VILLAGE OF MOUNT HOREB

PLAN COMMISSION AGENDA **Wednesday, June 24, 2026 at 7:00 PM**

To: Village of Mount Horeb Plan Commission
From: Village Planner: Ben Rohr, AICP
Date: June 24, 2026
Re: Specific Implementation Plan (SIP) and Design Review for 21 Proposed Single-Family Homes at the Southern End of Brookview Trail for Brookstone South, LLC.

Exterior Elevations

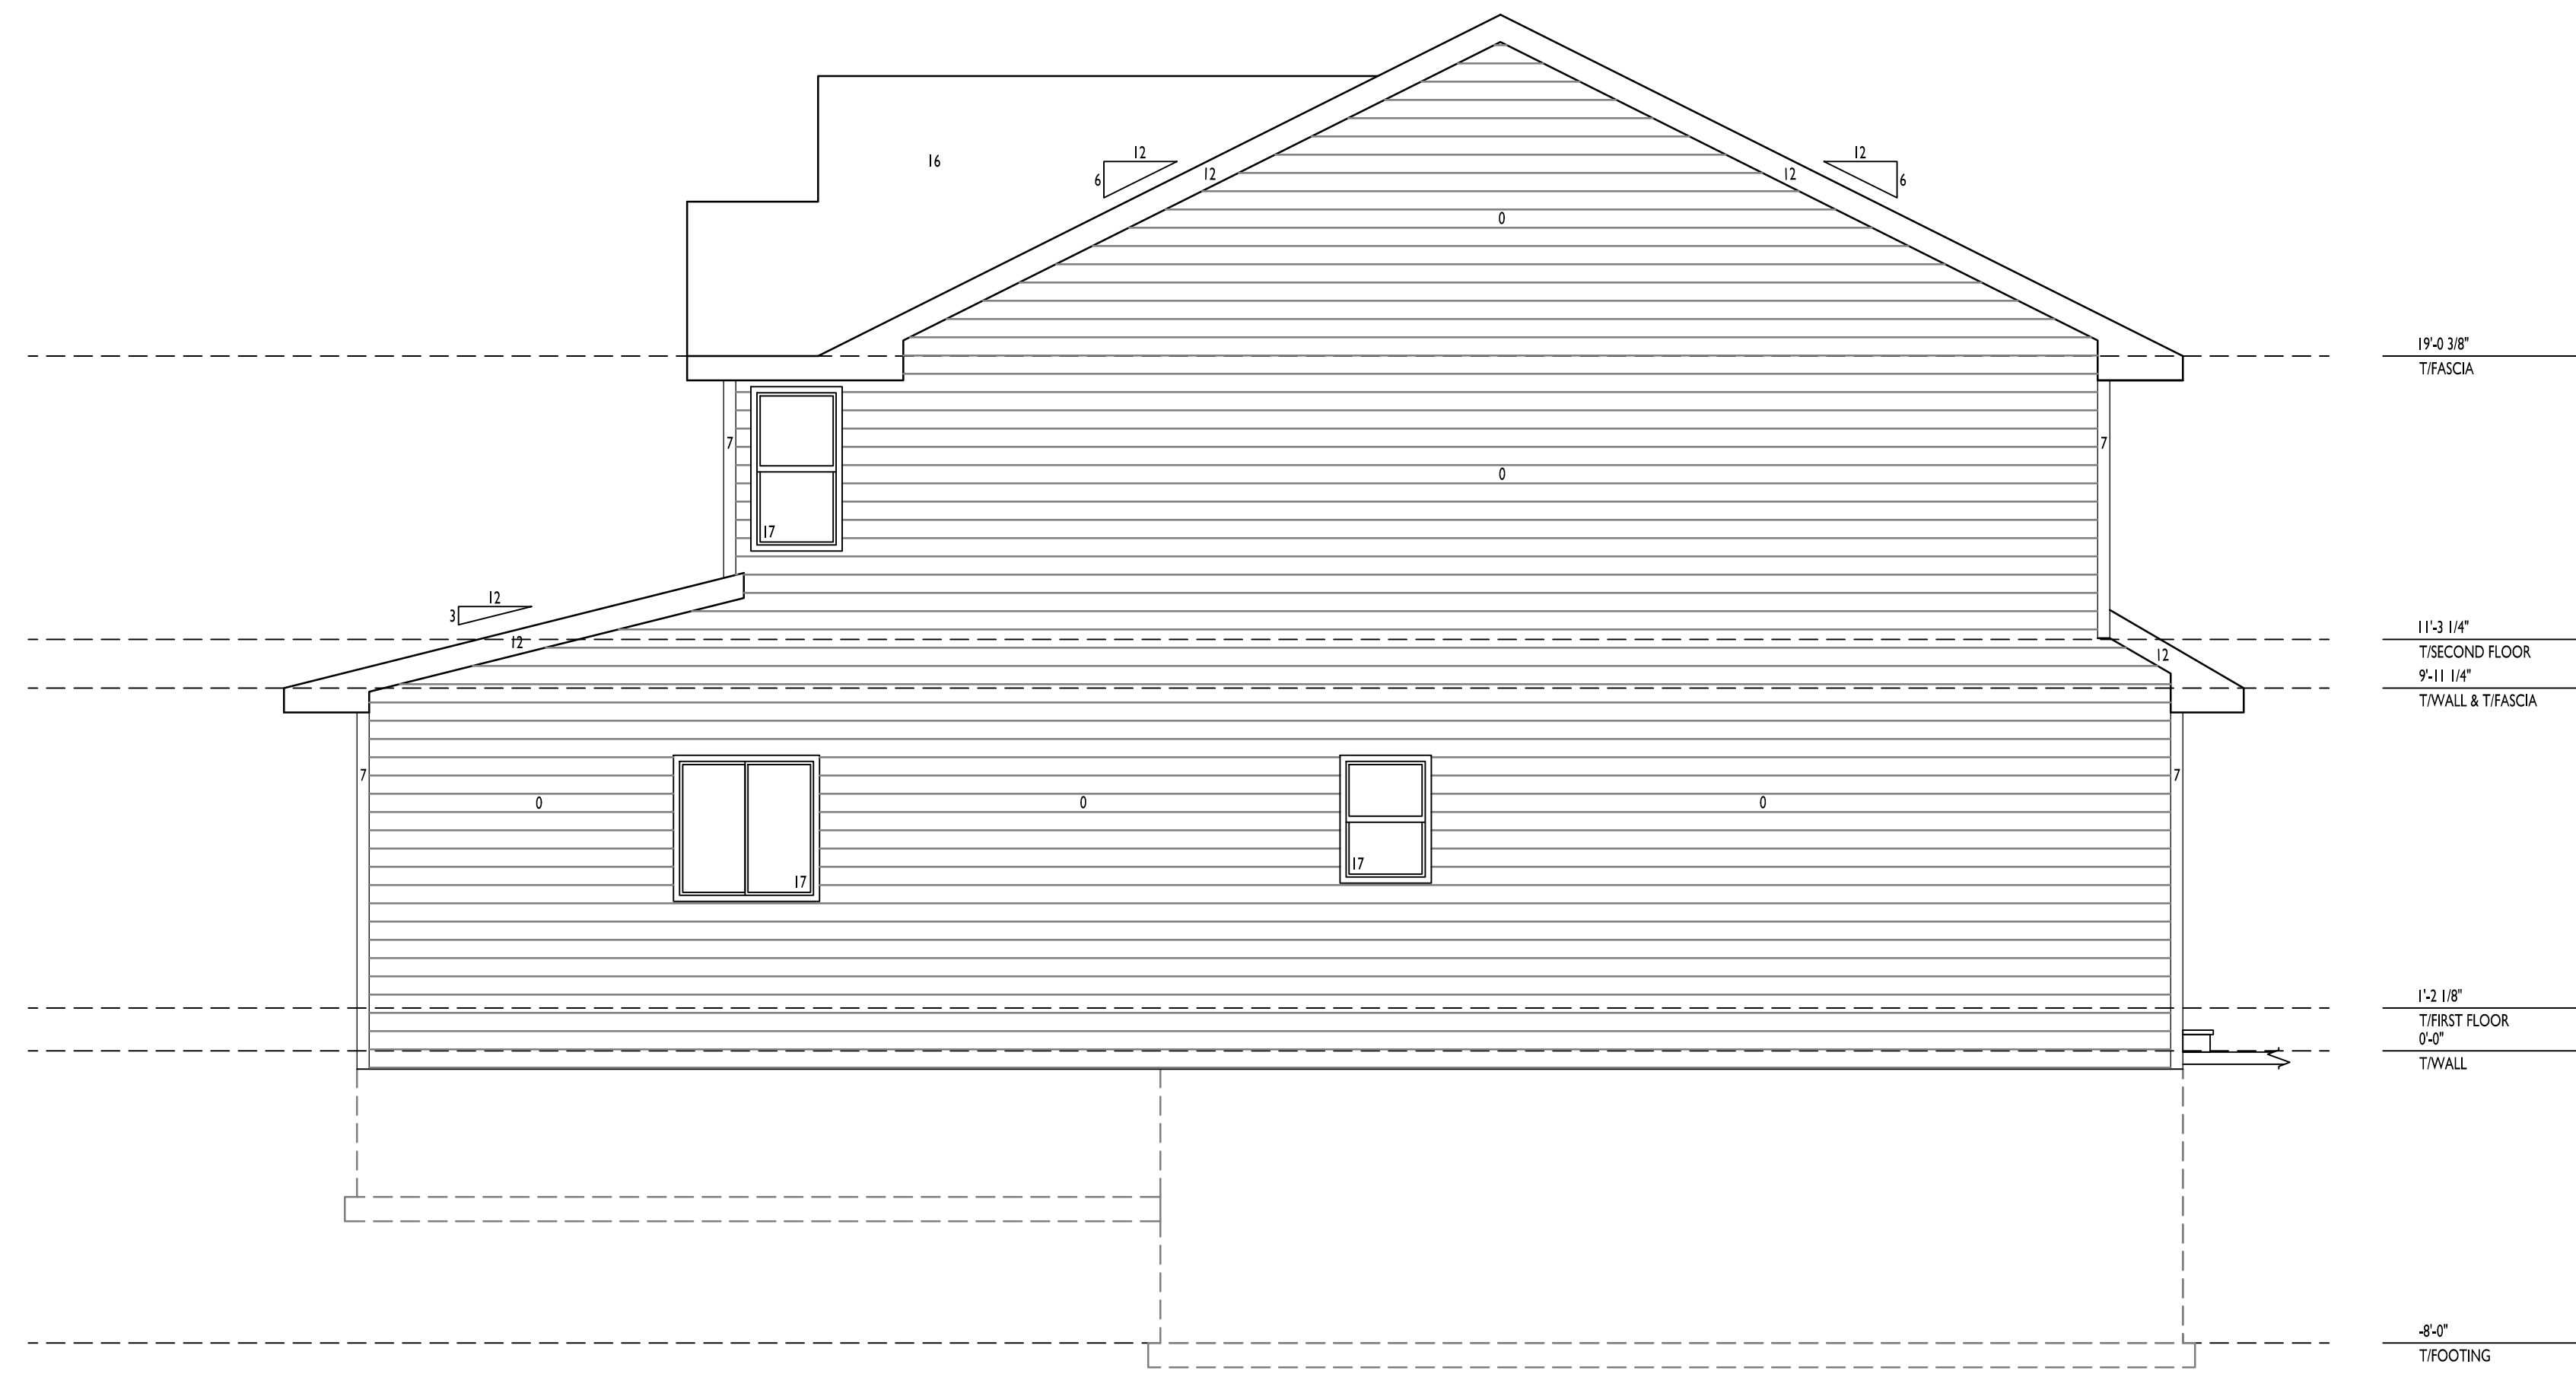
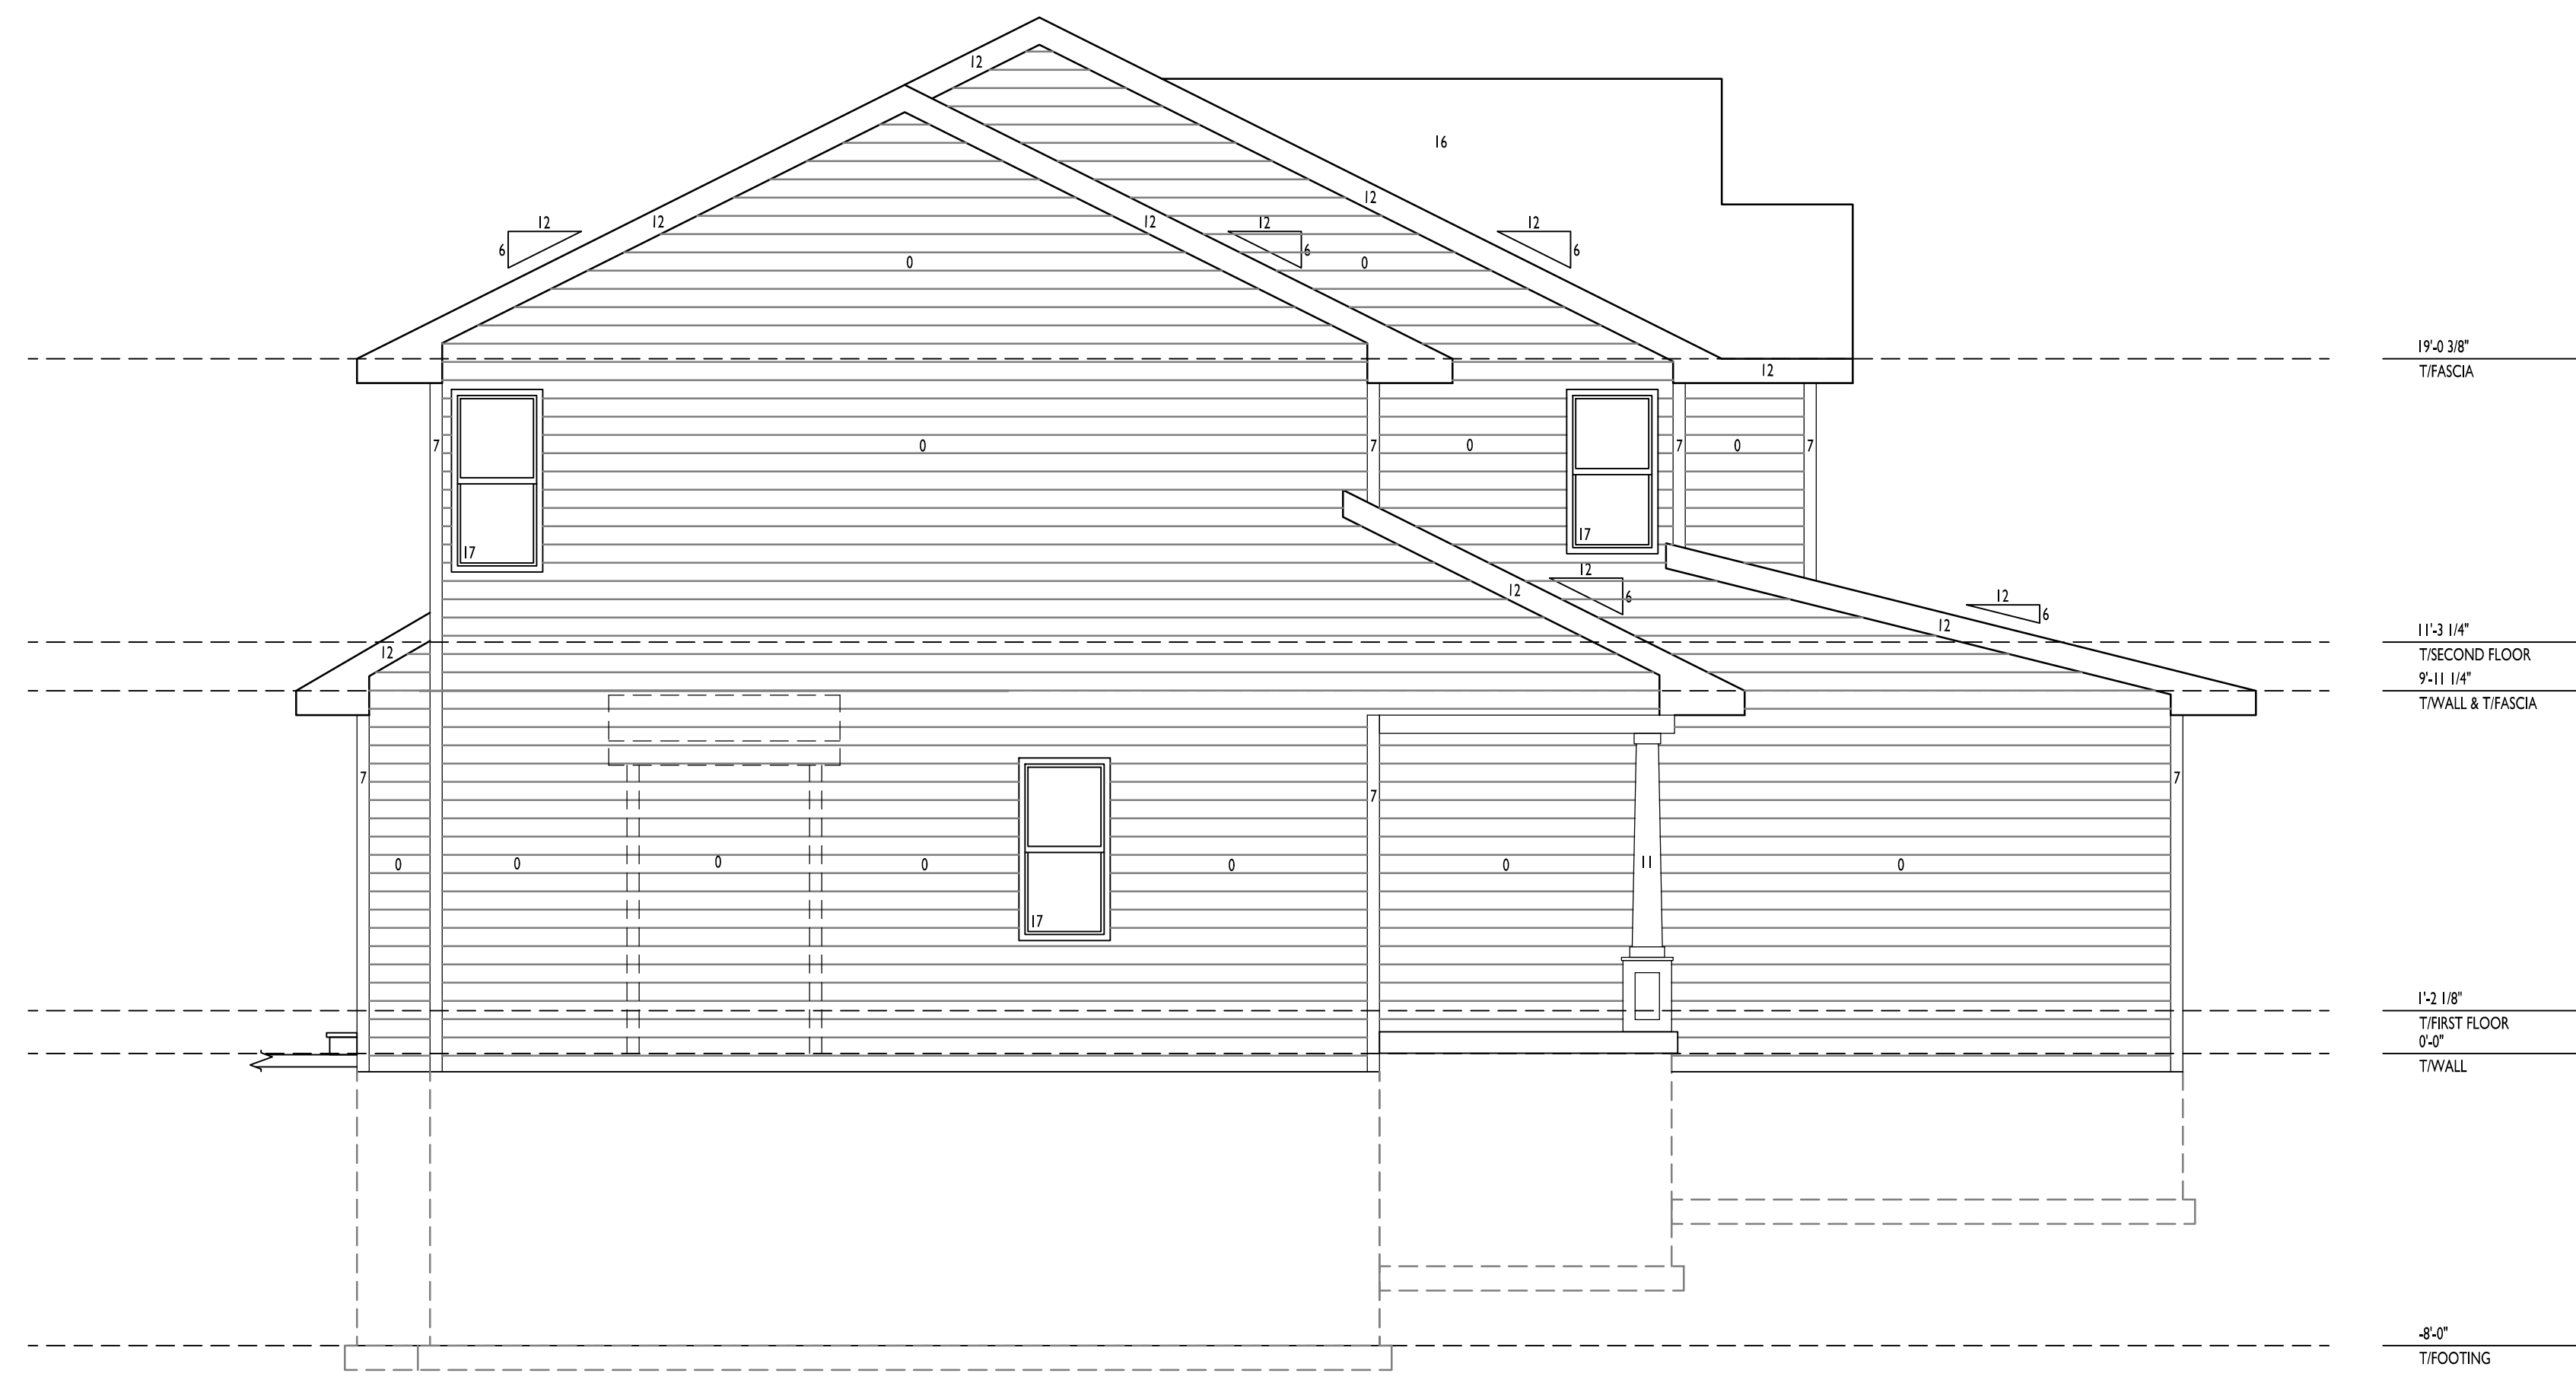
- a. Long building facades shall be visually broken up and variegated with staggers and offsets as determined appropriate by the Plan Commission.
 - This requirement is met on the front and rear elevations of each unit through varying roof pitches, windows, and doors. This requirement is not met along the side facades of each structure where very little articulation is proposed. Because each unit will be 12 feet apart, limited widow openings are necessary to provide privacy between the units. Additionally, this project is more in line with a single-family neighborhood where there are often longer building facades without articulation. I recommend the Plan Commission waive this requirement for the side facades for these reasons.

- b. All building facades facing streets, drives or parking areas shall provide regularly spaced openings for windows and doors, and regularly spaced decorative elements such as piers and columns. The size and spacing of these features shall be compatible with nearby structures that meet this requirement, as determined by the Plan Commission.

- This requirement may be met. The prominence of the front-loaded garage was discussed during the GDP and concept review meetings for this project. I recommend the Plan Commission discuss this requirement again.

- c. All building facades facing streets, drives or parking areas shall provide a pattern of upper story openings that is compatible with the pattern established by the ground floor, as determined by the Plan Commission.

- This requirement may be met. The prominence of the front-loaded garage was discussed during the GDP and concept review meetings for this project. I recommend the Plan Commission discuss this requirement again.

- This requirement is not met. No architectural base feature is included within any proposed unit type. I recommend that the Plan Commission discuss this item further.

- a. Finding that the proposed front façade of each structure reflects previous Plan Commission comments regarding reducing the prominence of the front-loaded garages.

- b. Requiring resubmittal with an alternative front façade design that further reduces the prominence of the front-loaded garages.
6. Plan Commission Discussion and Action on either (related to requirement 8.b.):
